UNITED STATES PATENT AND TRADEMARK OFFICE

APPLICATION NO.	FILING DATE	FIRST NAMED INVENTOR	ATTORNEY DOCKET NO.	CONFIRMATION NO.
10/796,406	03/08/2004	Chad Aerts	3591-1347	9026
757	7590	05/30/2006	EXAMINER	
BRINKS HOFER GILSON & LIONE P.O. BOX 10395 CHICAGO, IL 60610			EDELL, JOSEPH F	
			ART UNIT	PAPER NUMBER
			3636

Office Action Summary	Application No. 10/796,406	Applicant(s) AERTS, CHAD	
	Examiner Joseph F. Edell	Art Unit 3636

DETAILED ACTION

Diagram A - Annotated Figure 3 of Miotto et al.

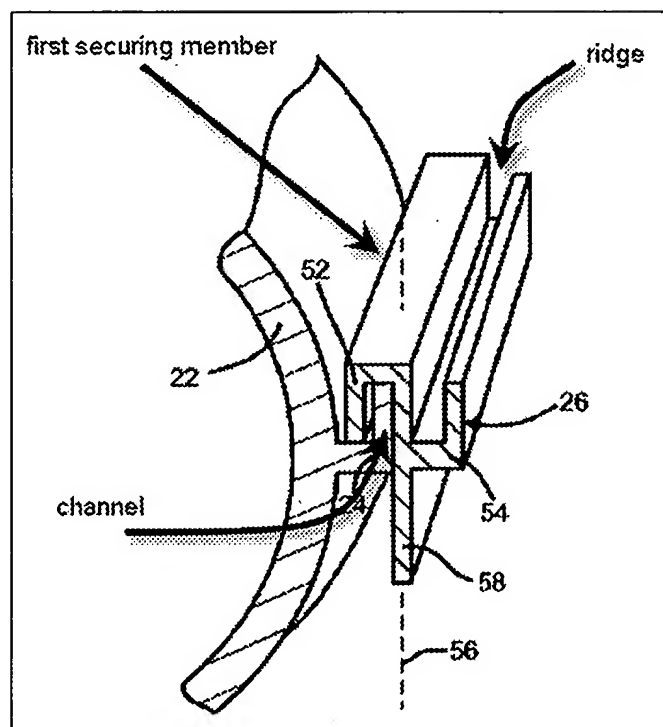
5. Applicant's arguments filed 15 March 2006 have been fully considered but they are not persuasive. With respect to claims 1 and 34, Applicant argues that furniture component of Miotto et al. does not teach the first securing member comprising a channel, a fabric piece disposed around at least a portion of the securing member, or a second securing member disposed around the first securing member with the fabric piece secured between the first and second securing members. Diagram A shows the configuration of the structural elements of Miotto et al. wherein the first securing

member has a channel, and Diagram B shows the fabric piece disposed around, i.e. enclosing, the tab portion 58 of the first securing member and the second securing member is disposed around the first securing member with the fabric piece secured between the first and second securing members.

Next, Applicant argues that neither the first securing member nor second securing member has a ridge. See Diagram A showing that the first securing member of Miotto et al. has a ridge.

Diagram C - Annotated Embodiment of Miotto et al. shown in Figures 6 and 2

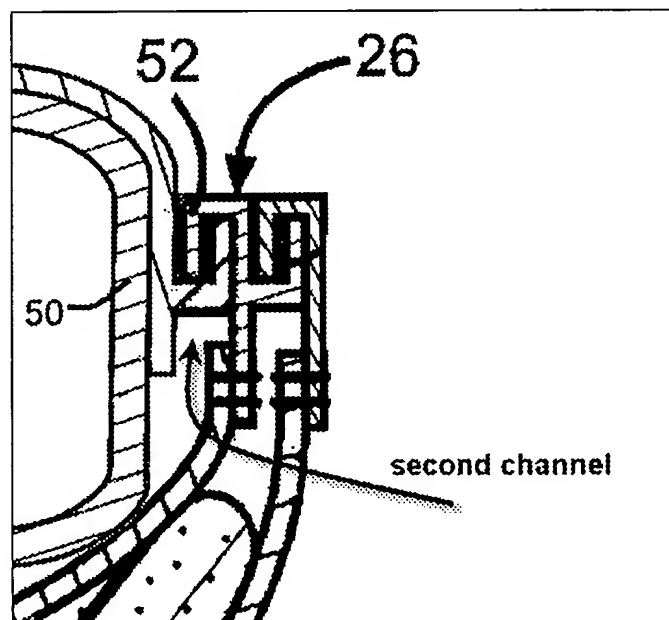
With respect to claim 14, Applicant argues that Miotto et al. fails to teach a fabric piece disposed within a channel. See Diagram C showing the channel housing the fabric piece.
